# HEALTH GP-18-037

## Building Permit Application

RE: B18000037, 12406 All Daughters Lane, 'On Hold'

**ONSITE SEWAGE DISPOSAL SYSTEM DESIGN PLAN**

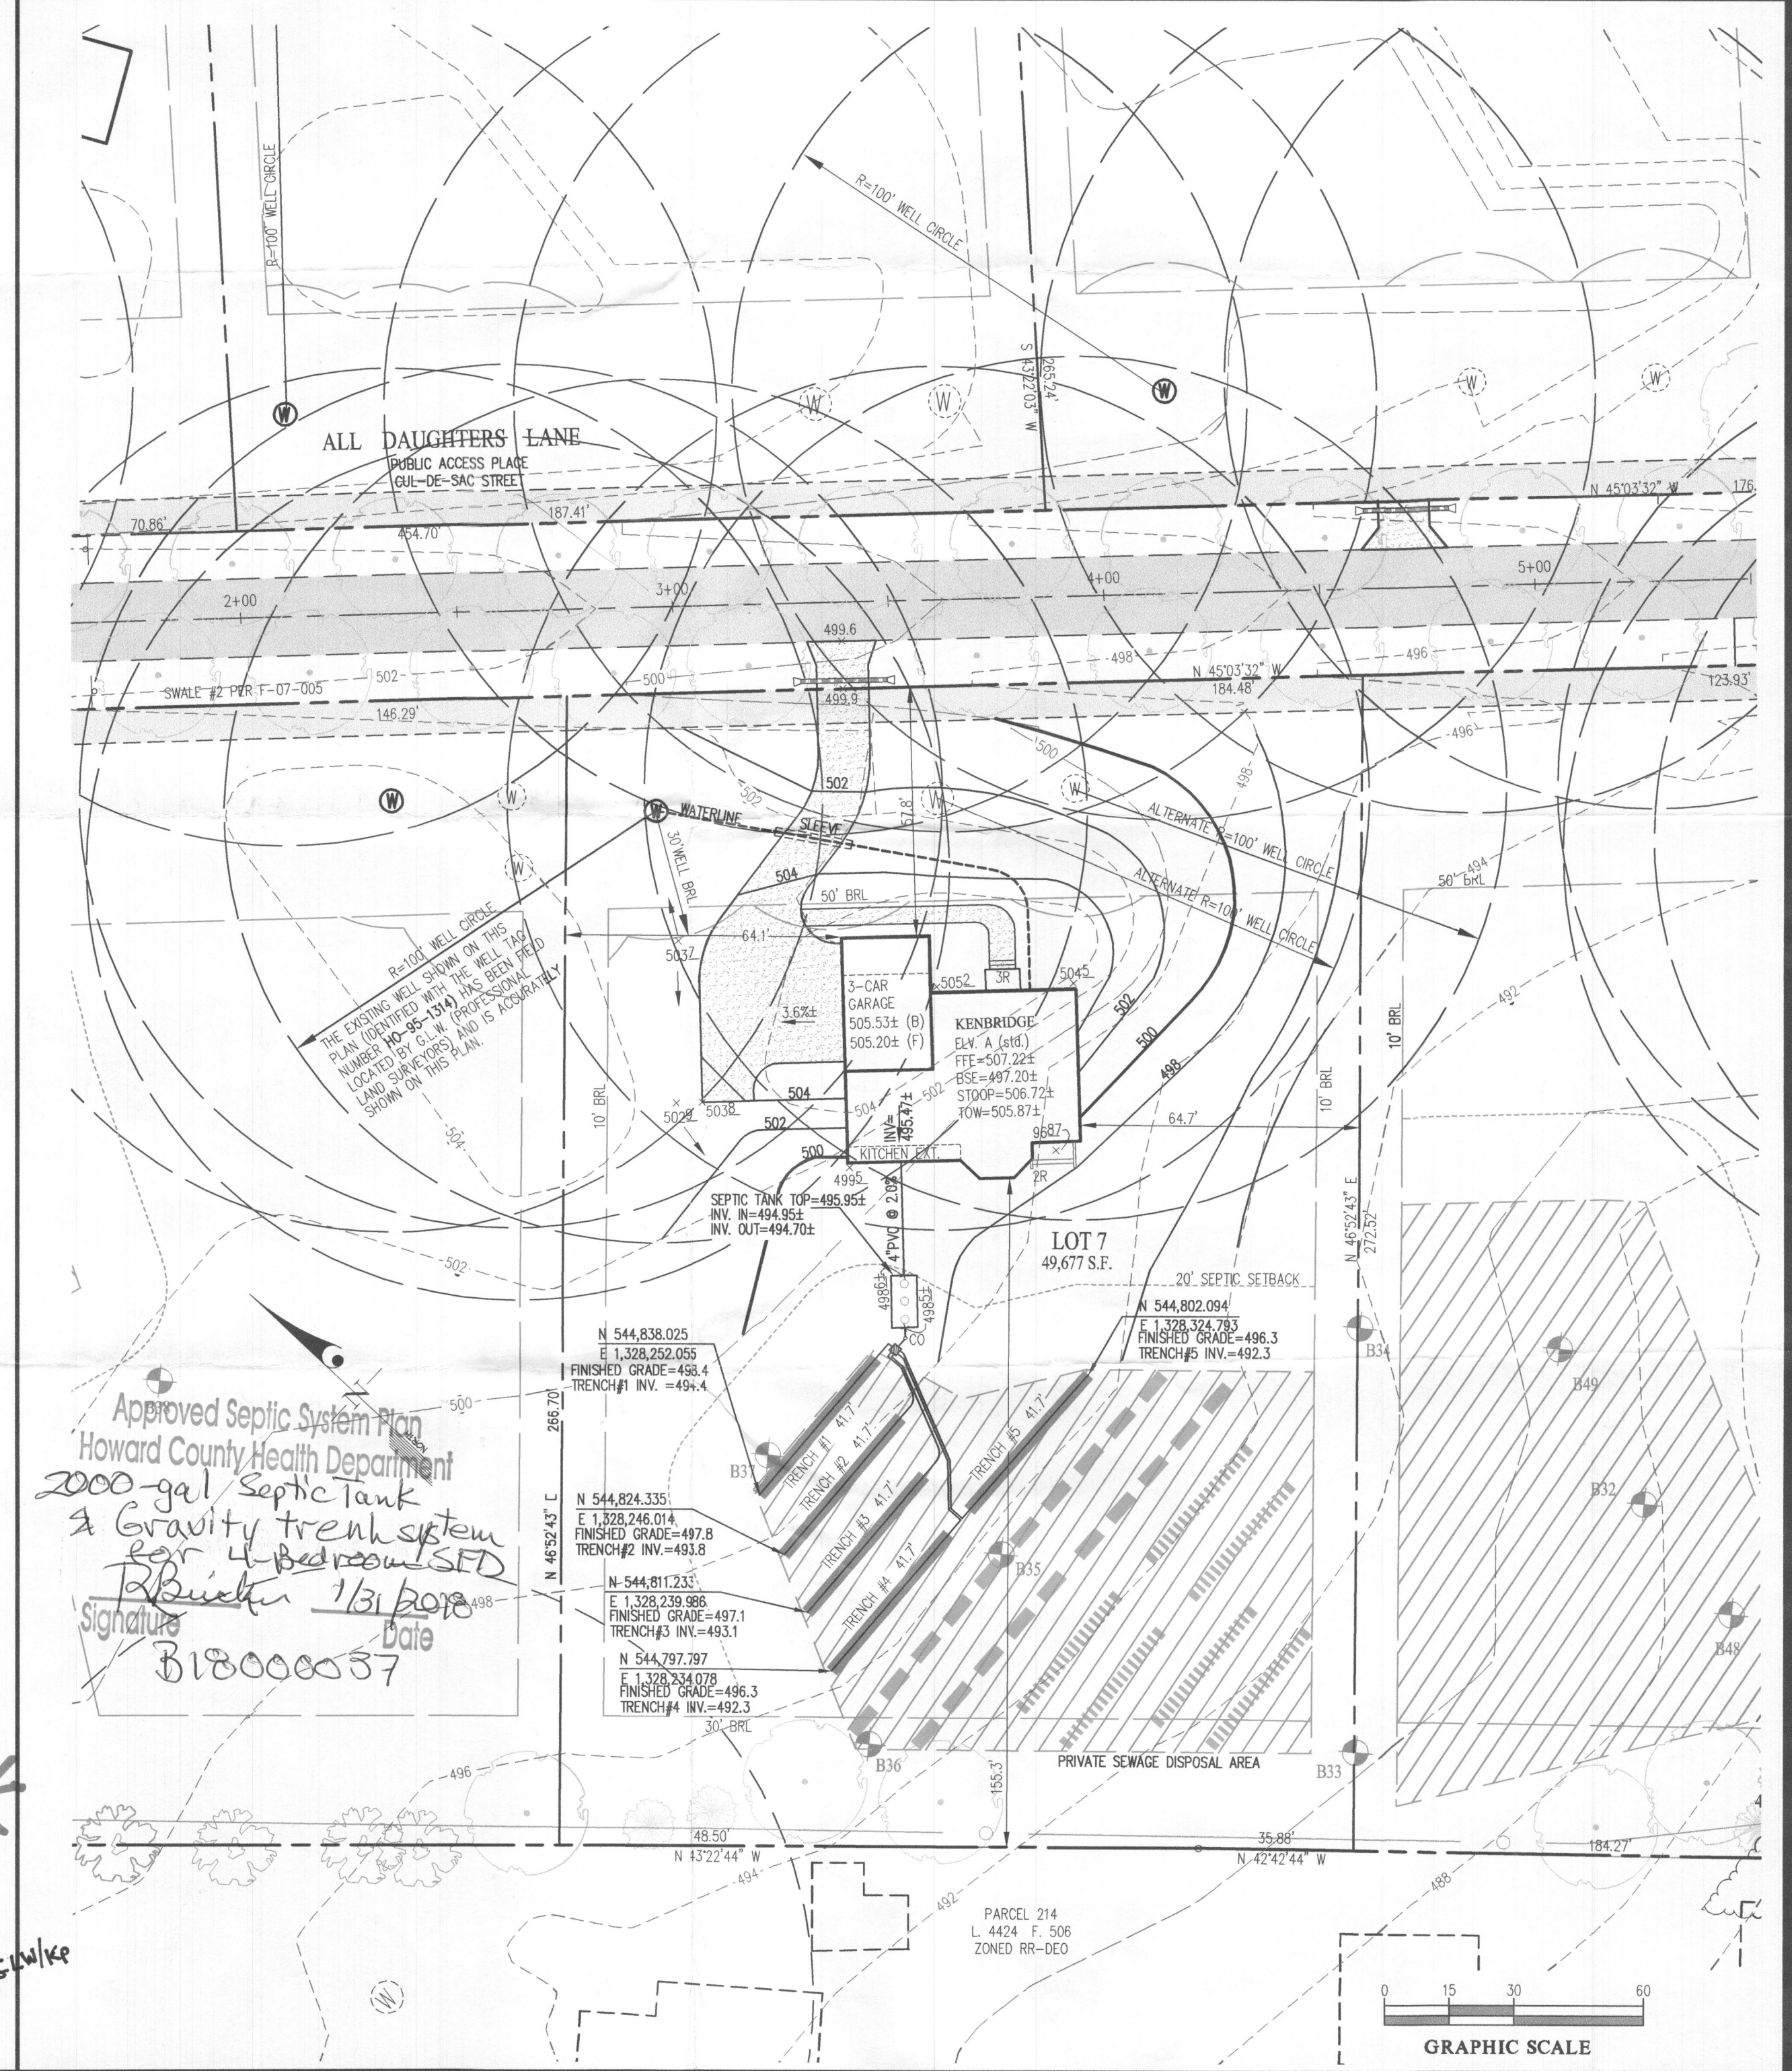
The proposed construction of a single-family dwelling at 12406 All Daughters Lane (Orchard Estates, Lot 7) is **On-Hold**. The soil resource on the lot has limitations such that there is space enough in the sewage disposal area for three drainfield systems for a four bedroom SFD. A revision of the onsite sewage disposal system (OSDS) plan for a 4-bedroom SFD has been received and shall be reviewed by February 1.

THE SUBJECT PROPERTY HAS A LIMITATION OF FOUR (4) BEDROOMS UNLESS AN EXHIBIT PRESENTED BY A CERTIFIED PROFESSIONAL DEMONSTRATES THAT THE SEWAGE DISPOSAL AREA WILL ACCOMMODATE THE WASTEWATER DISCHARGE FOR A RESIDENCE HAVING MORE THAN 4 BEDROOMS. ~~THIS LIMITATION WILL BE REMOVED THROUGH THE SUBMITTAL OF AN EXHIBIT TO THIS EFFECT. THE ENGINEER'S RESPONSIBILITY IS TO APPROVE THE SEWAGE DISPOSAL SYSTEM PLAN AS A COMPONENT OF THE SEPTIC SYSTEM. 105 per sq. ft.~~

BASEMENT PLAN @ ELEV. A & C

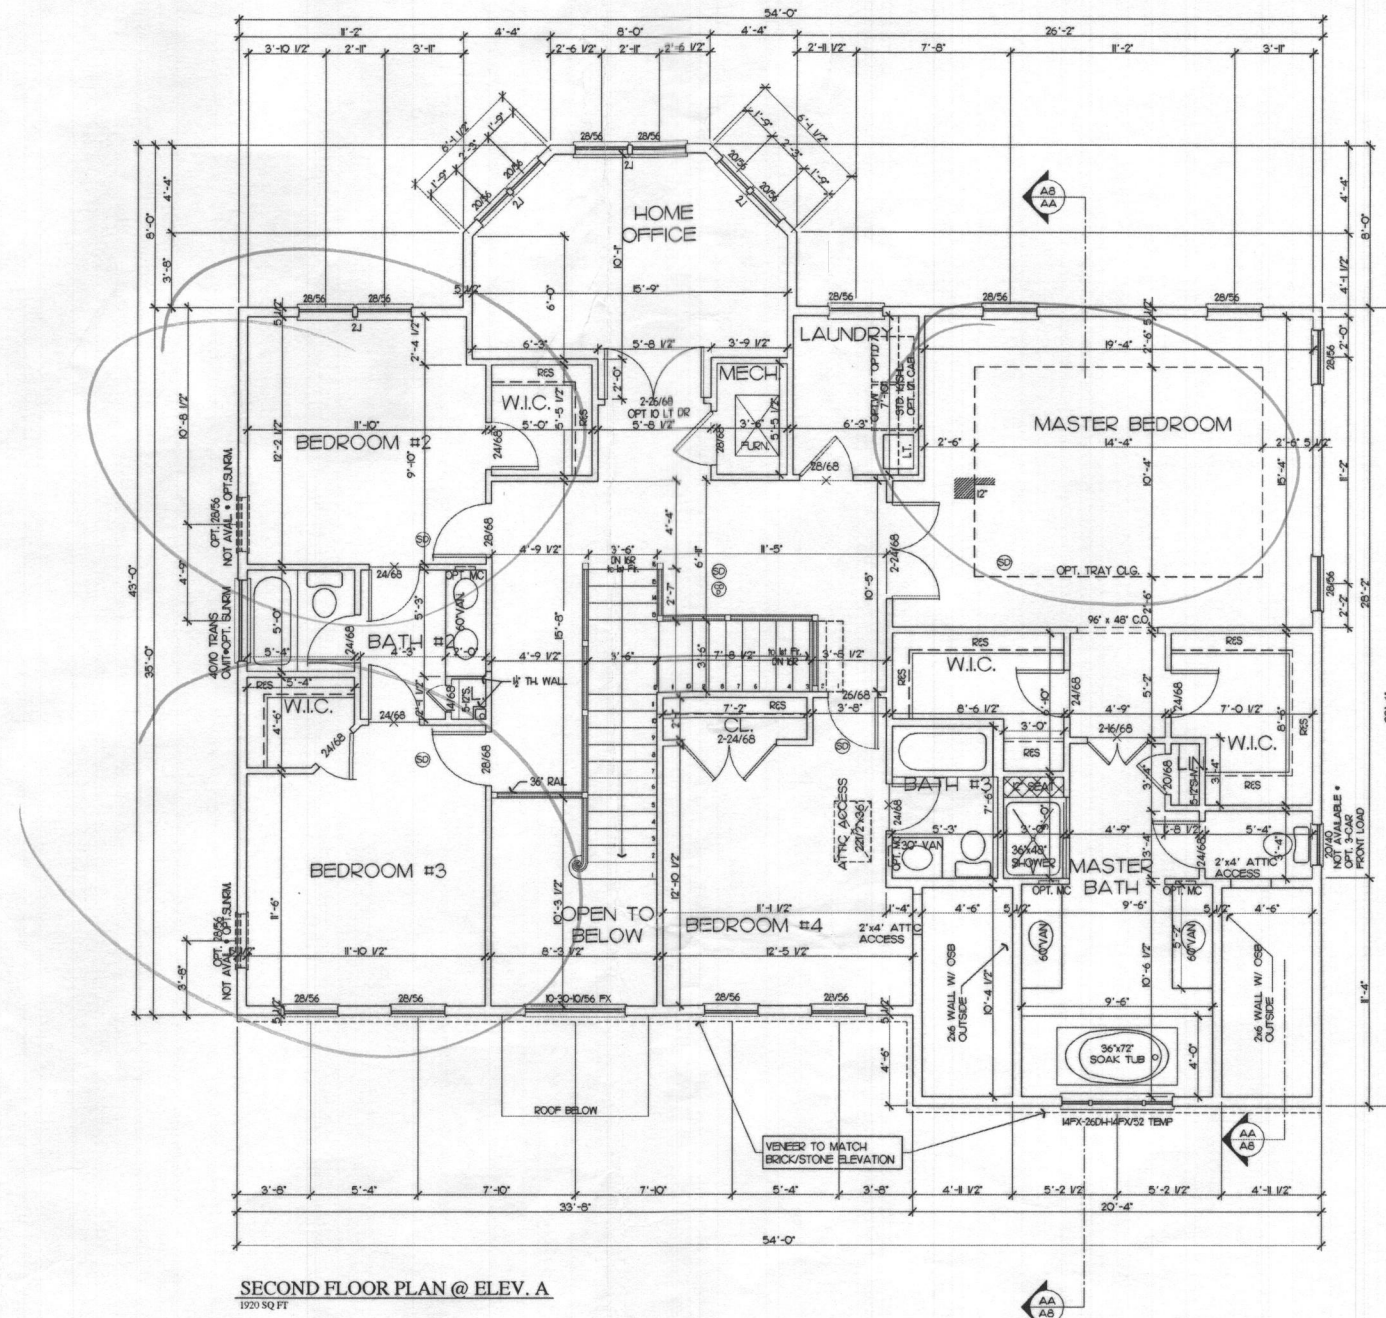
Robert: Marc Quint came in last night and marked the plans up for this lot, to show that only a half bath would be installed and there would not be a tub in this area.

Review of the floor plans submitted to the Health Department's attention was completed and the results compared with floor plans submitted to the attention of Howard County Department of Inspections, Licenses, and Permits (DILP). The Health Department copy was marked with red ink while the DILP copy was not marked. The markings on the Health Department copy would indicate that a Powder Room (half-bath) was proposed for the basement while the DILP copy indicated a full bath ("OPT BATH") next a room having an egress window and described as described as "OPT DEN/OPT BEDROOM". The plan submitted to DILP would be interpreted as potentially having 5-bedrooms while the marked-up copy submitted to the Health Department would be interpreted as only a 4-bedroom SFD by definition of bedroom in Howard County Code [3.801(B)]. As there are clearly 4 bedrooms on the 2<sup>nd</sup> floor, the basement floor plan must be revised so that there are no rooms that fit the Code definition of bedroom. I am enclosing the Code definition of bedroom with these comments. The conflicting information in the original application submittal is reason to require that three identical copies of revised floor plans be submitted at DILP. The Transmittal Sheet should indicate that one copy shall be forwarded to the Health Department.

Cannot be a bedroom  
 2nd level has 4 bedrooms  
 2-pc Bath

TITLE  
 SECOND FLOOR  
 PLAN @ ELEV. A

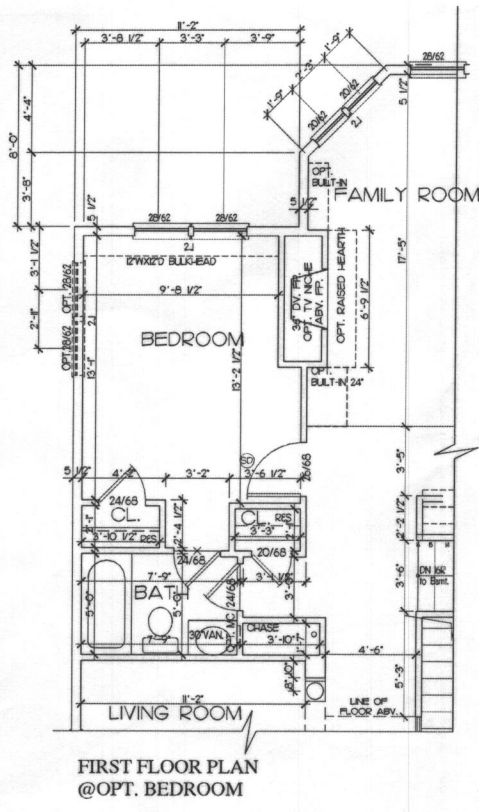
*2nd Floor  
 4 Bedrooms*

TITLE  
 FIRST FLOOR PLANS @ ELEV A & C

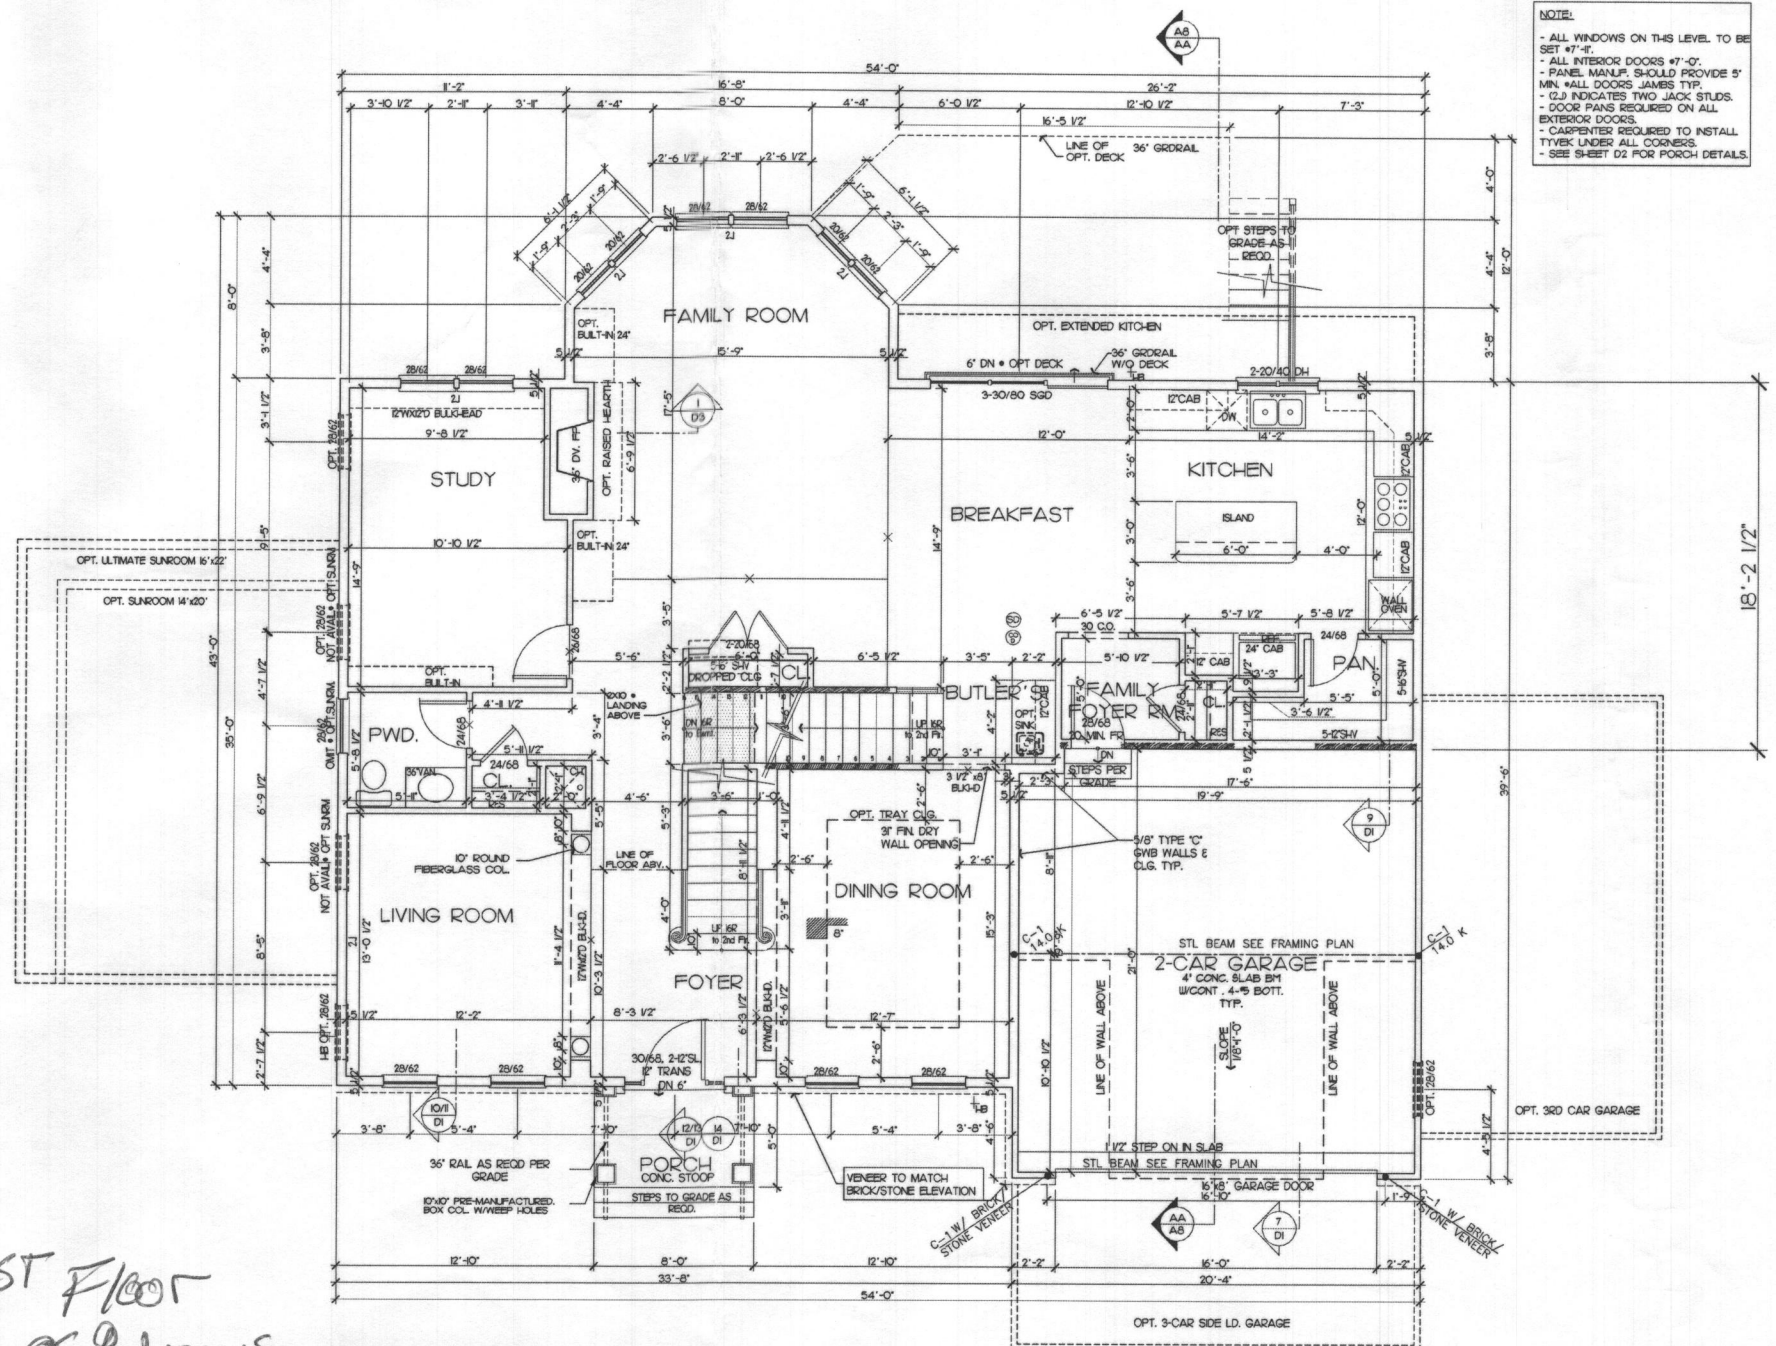
1st Floor  
 0 Bedrooms  
 B18000037  
 12406 All Daughters Lane
